ADDENDUM NO. 1
TO THE BID DOCUMENTS FOR:

JEFFERSON PARISH SHERIFF'S OFFICE
WAREHOUSE TORNADO REPAIRS
1801 WESTBANK EXPRESSWAY
HARVEY, LOUISIANA 70058

Jefferson Parish Bid No.: 23-JULY-1701

JULY12, 2023

Structural Addendum Items

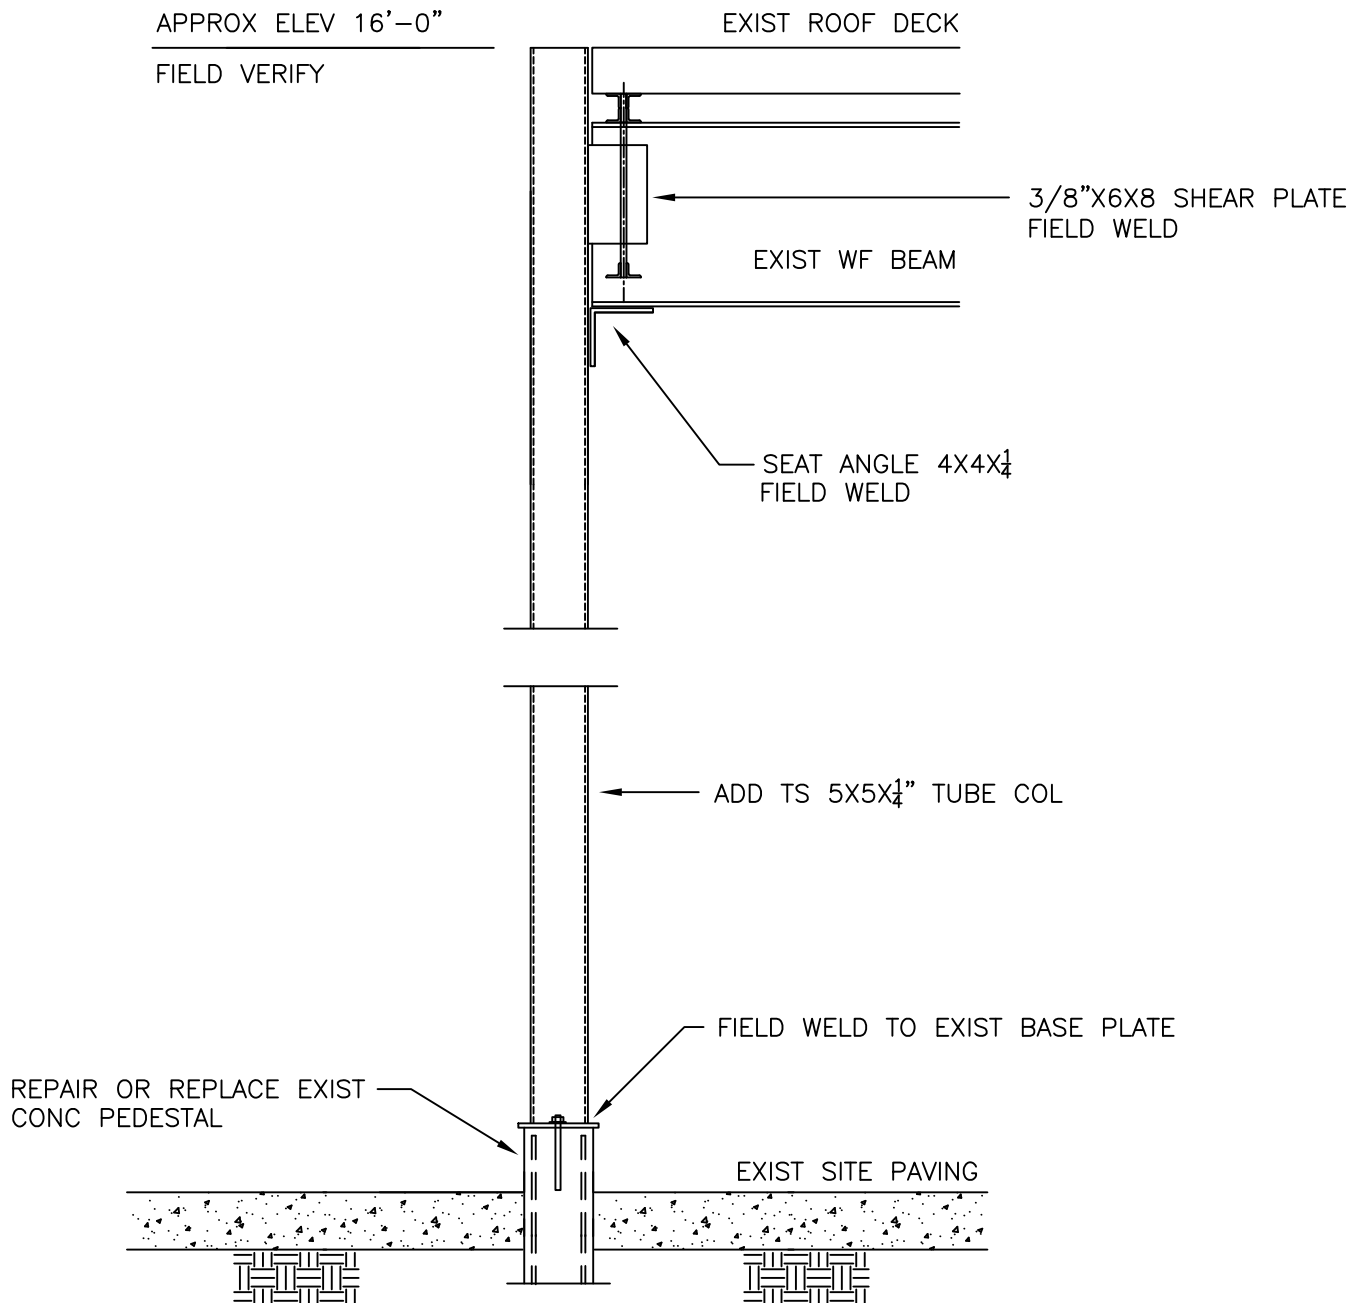
- 1) The connection at the base of all new 4” pipe stub columns shall be revised from field welded to field bolted. See attached Detail SK1. Holes shall be field drilled into the top flange of the existing steel beams to accept the new base plates.
- 2) The AISC Certification requirements in Spec Section 051200 shall be waived and replaced with the requirement that the steel fabricator and erector has at least 20 years experience in projects of similar size and scope.
- 3) There is currently a missing column at Line 2J. A 5x5x ¼ tube column shall be added at this location. See attached Detail SK2.
- 4) The existing damaged column at Line 8H shall be removed and replaced. See attached Detail SK3. The GC shall provide temporary shoring as needed.

SK3

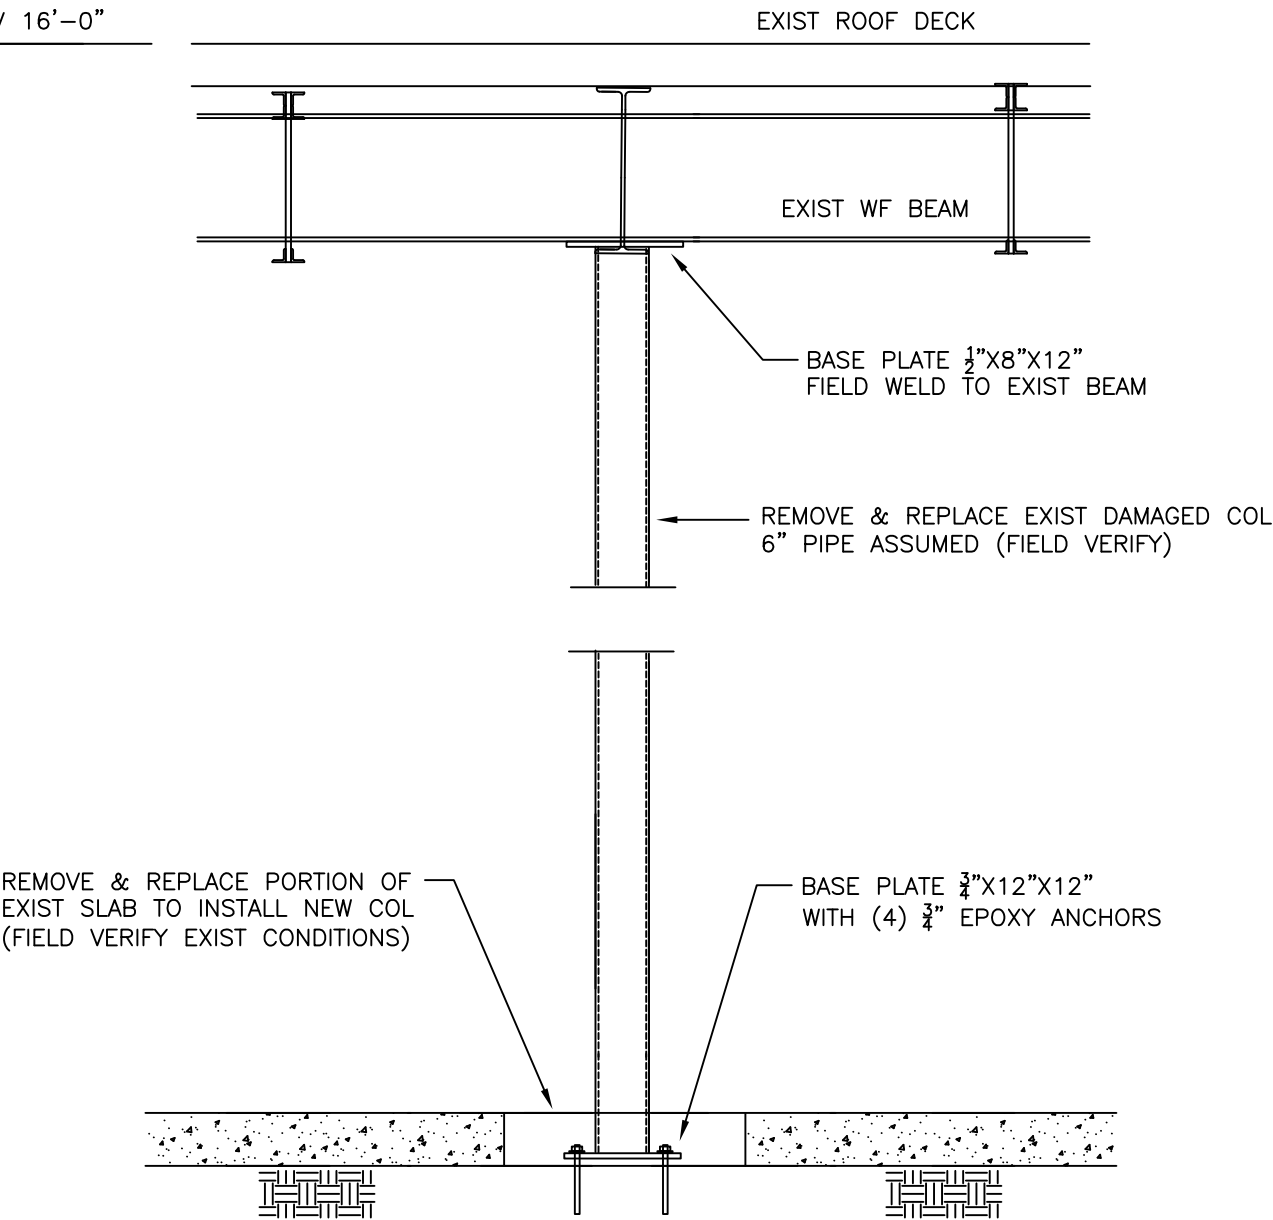
1. A Link to Remediation Contractor's Website is provided as follows:
<https://www.dropbox.com/sh/gspgkb8o4draia9/AACmjKv4Qh3mGz387dG6uzSCa?dl=0>
2. Add Column Repairs to Scope of Work at Columns 2J (SK2), and 8H (SK3) per Robert Bouchon Sketches attached to this Addendum.
3. See revision to provide **Bolted Connection Detail** per Robert Bouchon Sketch (SK1) attached to this Addendum.
